UNITED STATES PATENT AND TRADEMARK OFFICE

APPLICATION NO.	FILING DATE	FIRST NAMED INVENTOR	ATTORNEY DOCKET NO.	CONFIRMATION NO.
10/637,191	08/08/2003	Jurgen Muller	P2001,0082	3966
24131	7590	08/18/2005	EXAMINER	
LERNER AND GREENBERG, PA			NGUYEN, PHILLIP	
P O BOX 2480			ART UNIT	
HOLLYWOOD, FL 33022-2480			PAPER NUMBER	
			2828

Office Action Summary	Application No. 10/637,191	Applicant(s) MULLER, JURGEN	
	Examiner Phillip Nguyen	Art Unit 2828

DETAILED ACTION***Response to Arguments***

Fig. 5

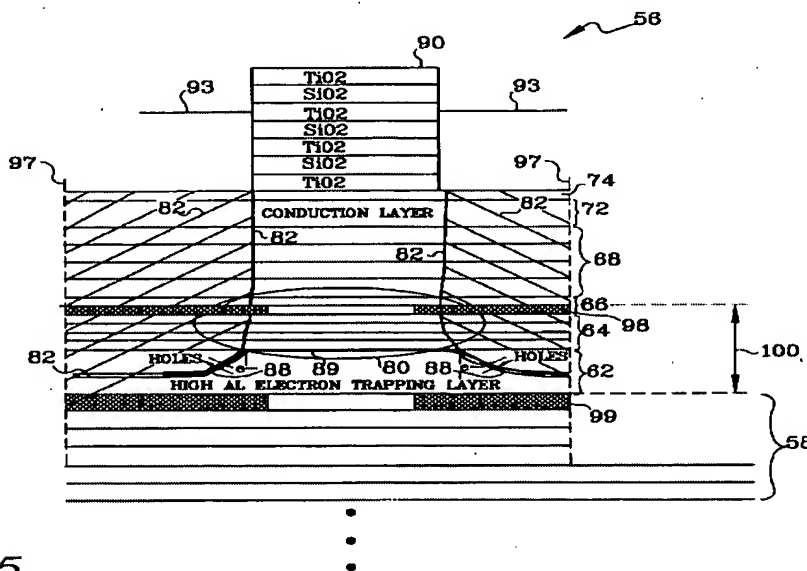
With respect to claim 1, Johnson discloses in Fig. 5 a semiconductor laser comprising a vertical resonator formed by reflectors (90 and 58); a photon-emitting active layer (80) disposed between said reflectors; at least one current diaphragm (98 and 99) for laterally circumscribing a current flowing through said photon-emitting active layer; and mode-selective regions (82) extending from a vertical direction within said vertical resonator and laterally delimit said vertical resonator.

With respect to claim 2, Johnson further discloses a mesa and one of said reflectors (90) is formed in said mesa.

With respect to claim 4, Johnson discloses the current diaphragm is formed from an oxide (col. 6, lines 15-16).

With respect to claim 8-9, Johnson discloses said mode-selective regions have an electrical conductivity less than an electrical conductivity of said vertical resonator along a resonator axis and said mode-selective regions are implantation regions (abstract).

With respect to claim 10, Johnson discloses said vertical resonator has an edge area (97) and said mode-selective regions extend in said edge area and a surrounding region of said edge area of said vertical resonator.

With respect to claim 11, Johnson discloses said current diaphragm is at least two current diaphragms (98 and 99).

With respect to claim 12, Johnson discloses the semiconductor laser has a multilayer structure (from layers 58-90) and said mode-selective regions are formed within said multilayer structure.

With respect to claims 3 and 5-6, Johnson discloses the claimed invention and also the mode-selective region defining an inner opening being larger than said current aperture (see Fig. 5) except for explicitly teaching the diameters of the mesa and aperture. Choquette discloses in Fig. 1 the claimed invention along with a mesa has a diameter of larger than 10 and a current diaphragm 20 defines a current aperture having a given diameter of larger than 3 μm (col. 9, lines 59-65) except for the mode-selective region being within said resonator. For the improvement of the laser device, it would have been obvious to the one having ordinary skill in the art at the time the invention was made to provide diameters of the mesa and current aperture larger than 10 μm and larger than 3 μm , respectively, because it is well known in the art to design such diameters.

With respect to claim 7, Johnson discloses in Fig. 5 the mode selective regions defining an inner opening being larger than said current aperture.
